# Attachment 3 – Urban Design Statement Addendum, FJMT

Blackwattle Bay  
Response to Submissions

June 2022

Project Name			Blackwattle Bay Revised Precinct Plan
Project Code			BMD
Document Name			Response to Submissions - Urban Design Statement Addendum
Revision	Date	Approved	
Final	21/06/2022	DH

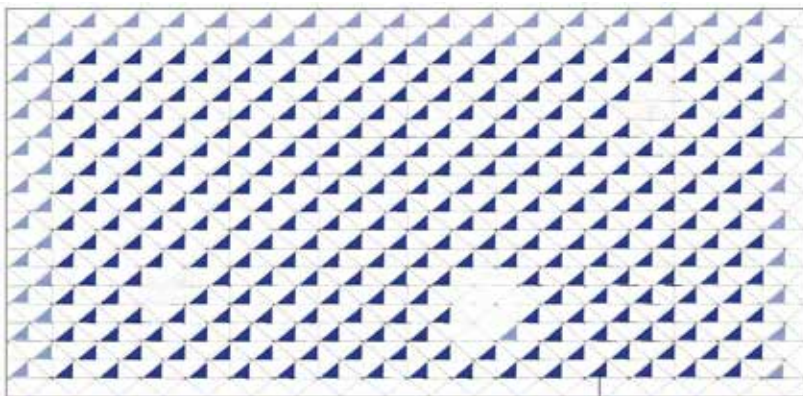
- Future development would overshadow the solar panels proposed for the new Sydney Fish Market

- Building 03 reduced by 15m
- Building 04 reduced by 4m

The revised building heights for Blackwattle Bay have been developed with consideration given to solar access to the new Sydney Fish Market including solar to the roof PV array.

/ Park Street North

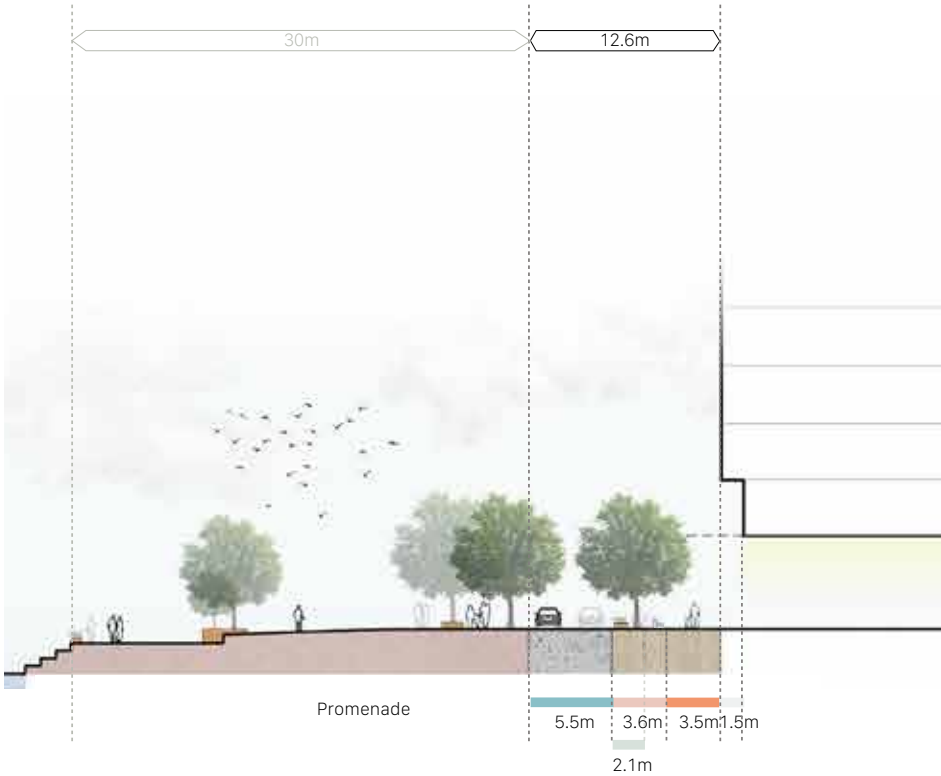
Park street is incorrectly described as a shared street. As an activity street, its combined footpath and furniture zone's preferred width is 5 metres. A width of 2.6 metres is provided on its western side and is considered inadequate. The 6-metre space for a footpath, furniture zone and outdoor dining needs to be wider to provide sufficient space for the intended extent of outdoor dining.

Park Street is an activity street that plays a vital role in separating the private domain of built form from the public open space of the promenade.

The street width has been amended to accommodate broad pedestrian movement paths, street furniture zones, outdoor dining and two-way vehicular traffic.

/ Gipps Lane

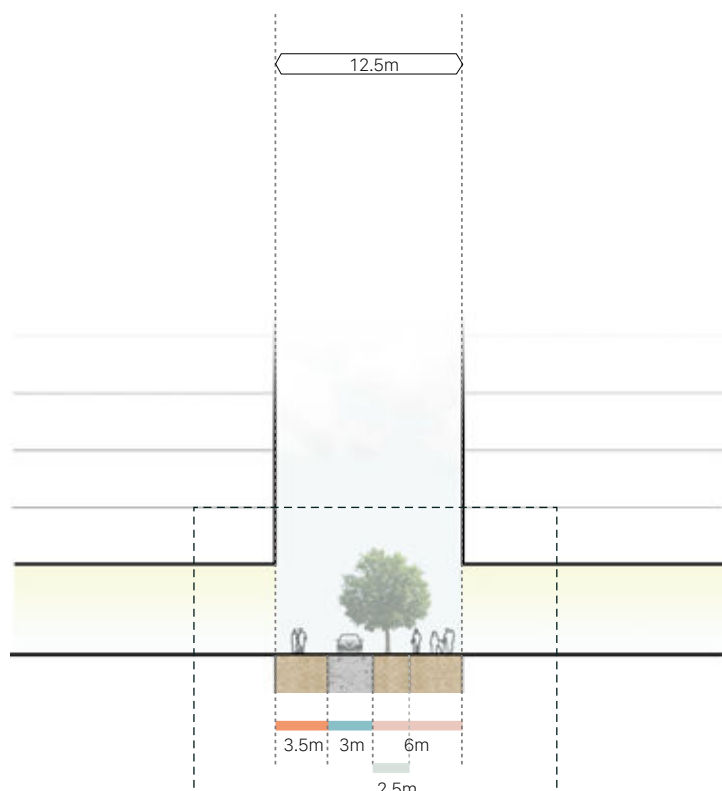
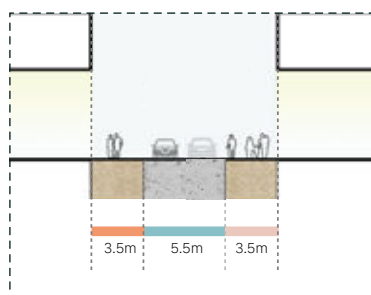
Gipps Lane is a local street. A combined footpath and furniture zone with a width of 3.5m is preferred. However, only 2.4 metres is provided on one of its sides and is considered inadequate. The vehicle lane should be 3 metres and not 3.5 metres. This space should be reallocated to landscaping, footpath or furniture zones. The central furniture zone is misplaced as one of its purposes of a furniture zone is to separate the footpath from moving traffic. The 5-metre space for footpath, furniture zone and outdoor dining needs to be wider otherwise the width of the outdoor dining area may be limited to 1 metre.

One way traffic and intermittent parking bays, or two way traffic, can be accommodated in Gipps Lane, providing flexibility through the staged renewal of Blackwattle Bay. Pedestrian movement and street furniture zones are increased to 3.5m to align with the Sydney Street Code 2021.

Outdoor dining is removed as Park Street and Park Lane offer better amenity around the middle of the day for seating outdoors in the Revised Precinct Plan.

# Bank Lane

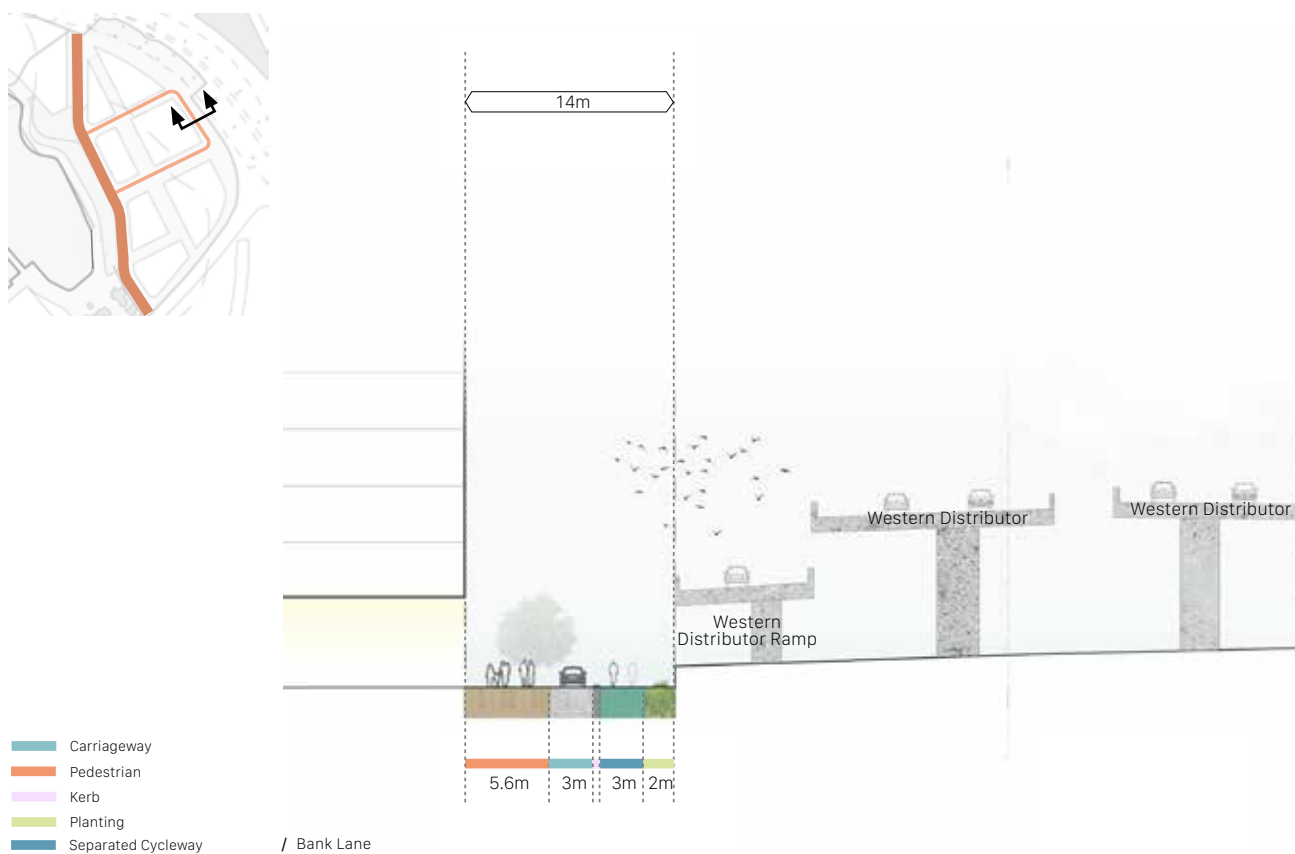
Bank Lane is a local street. Its combined footpath and furniture zone's preferred width is 3.5 metres. However, an inadequate width of only 2.5 metres is provided. The vehicle lane should be 3 metres not 3.5 metres, this space should be reallocated to landscaping, footpath or furniture.

Bank Lane is local street running parallel to Bank Street and the Western Distributor. The lane is a key element in the active transport network and accommodates a separated cycle way and planting zone that also serves as a buffer for pedestrian movement from the Western Distributor Ramp.
